Access Compliance Report

Public Rights-of-Way

(Curb Ramps)

Intersection ID: 5104	Main Street: E_MALLARD_CREEK_CHURCH_RD	Cross Street: MARY_ALEXANDER_RD	Location: E
ADA ID: FBEE6085A4EE	Ramp Type: Perp	Initial Pass/Fail: Fail	Overall Compliance: No
Severity Score: 21.25			
Codes/Mitigation Info/Possible Solution		Field Measurements/Component Compliance

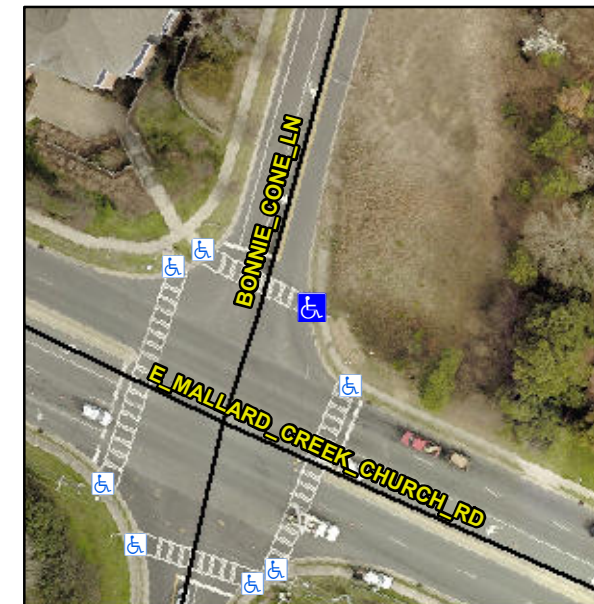
R304.5.1, R304.2.2

Compliance	Description	Data	Compliance	Description	Data
N/A	Ramp Length (in)	71.0	No	Ramp Slope (%)	10.5
No	Ramp Width (in)	47.0	Yes	Ramp XSlope (%)	0.8
N/A	Flare Type LT	N/A	N/A	Flare Type RT	N/A
N/A	Flare Slope LT (%)	N/A	N/A	Flare Slope RT (%)	N/A
N/A	Flare Traversable LT?	N/A	N/A	Flare Traversable RT?	N/A
N/A	Landing Length (in)	N/A	N/A	DWS Provided?	N/A
N/A	Landing Width (in)	N/A	N/A	DWS Contrast?	N/A
N/A	Landing Slope (%)	N/A	N/A	DWS Length (in)	N/A
N/A	Landing X Slope (%)	N/A	N/A	DWS Full Width?	N/A
N/A	Landing Curb? (Y/N)	N/A	N/A	DWS Offset (in)	N/A
N/A	Shared Landing?	N/A			
N/A	Gutter Ponding?	N/A	N/A	Gutter Slope (%)	N/A
N/A	Gutter Lip Ht (in)	N/A	N/A	Gutter X Slope (%)	N/A
N/A	Painted X Walk1?	Yes	N/A	Painted X Walk2?	N/A
	X Walk 1 Direction	To NW		X Walk 2 Direction	N/A
N/A	X Walk 1 Width (in)	108.0	N/A	X Walk 2 Width (in)	N/A
	X Walk 1 Slope (%)	0.3		X Walk 2 Slope (%)	N/A
	X Walk 1 X Slope (%)	1.4		X Walk 2 X Slope (%)	N/A

Remove & Replace Entire Ramp.
